Submission of representations and formal objection to planning application ref: 2021/3405/P at workshop rear of 38-52 Fortess road, Fortess grove, London NW5 2PA

"Part discharge of Condition 4 and fully discharge condition 17 of Planning Permission Ref: 2017/6788/P dated 18/05/2020."

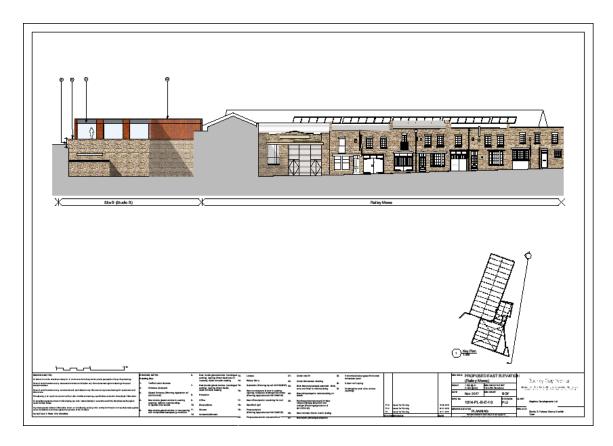
Application ref: 2017/6788/P granted 28th January 2019 is subject to a number of conditions that directly concern 2021/3405/P. Condition 21 provided as follows:

"The three windows hereby permitted at rear second floor level, depicted on plan 1014-PL-B-E-10 REV PL3, shall be constructed using only obscured glazing, fixed shut and shall be so retained.

2017/6788/P Proposed east elevation, 1014-PL-B-E-10 REV PL3 (three full length windows)

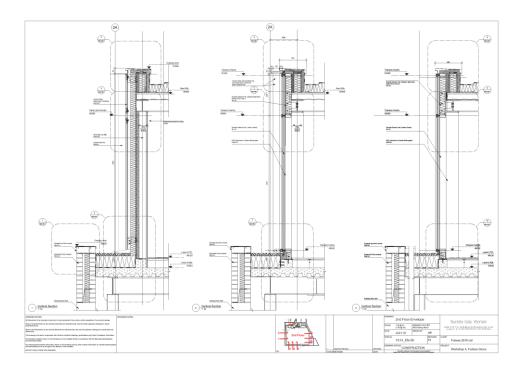
2021/3405/P drawing (Second floor envelope, 1014-EN-50 GL-01, Key 3, Vertical section 3) notes the second floor East facing full length windows double glazed is *Clear Vision Glass*.

2017/6788/P Condition 21 specifically conditions;

"The three windows shall be constructed using only OBSCURED glazing, fixed shut and shall be so retained"

By the use of clear vision glazing 2021/3405/P seeks to overturn 2017/6788/P Condition 21.

2017/6788/P condition 21 would not have been required by the Council if it was not necessary to protect residents amenity and privacy. There is no genuine reason for this position to now change. The Condition was set by the Councillors at the Planning Committee meeting.

For these reasons, this application should be *amended* or refused.

2017/6788/P conditions the three full length windows shall be *constructed* using only obscured glazing. We would be grateful if the applicant is made aware that the use of Vision glazing with removable obscure film does not comply with Condition 21. The window glazing should be *constructed* using only obscured glass.

2021/3405/P Envelope Details 1014\_EN-70. Key (C) Drawing (4) Existing window.

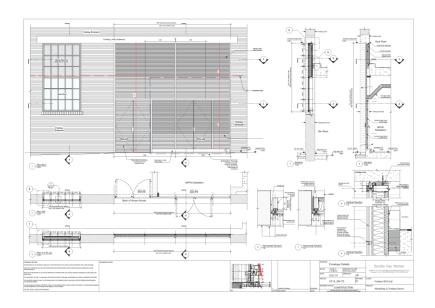
(A) 2021/3405/P Envelope Details 1014\_EN-70. Key (C) Drawing (4) Existing window. Railey mews east elevation window glazing specification notes:

("window top section) *glazed Spankrel solid Friton face 4 "(* window lower section) "Vision glass"

The application is effectively seeking to overturn 2017/6027/P - Proposed General arrangement first floor plan.1014-PL-C-01 Drawing key (K) Railey mews east elevation replacement window glazing specification. "Existing Window to be refurbished. Glazing to be replaced with OBSCURED glass"

We respectively request the east elevation Railey mews window glazing is also constructed using only obscured glazing not vision glass with removable obscured film.

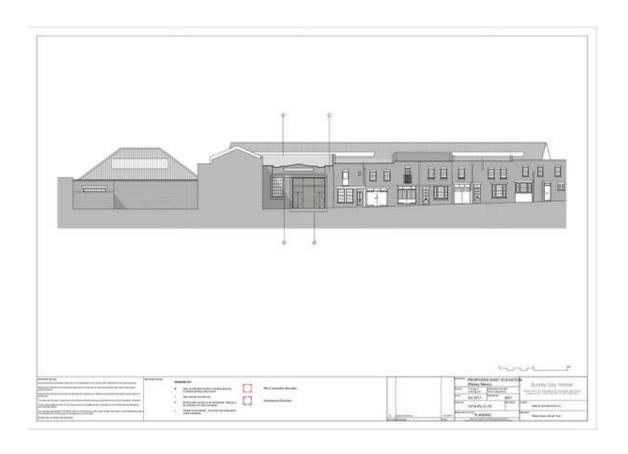
2017/6788/P Proposed east elevation, 1014-PL-B-E-10 REV PL3 does not provide specification for the replacement type of glazing to be used for the Railey Mews east elevation existing window. The replacement glazing specification for Railey mews east elevation window is provided for in the preceding application 2017/6027/P Proposed General arrangement first floor plan.1014-PL-C-01 Drawing key (K)

"Existing Window to be refurbished. Glazing to be replaced with OBSCURED glass"
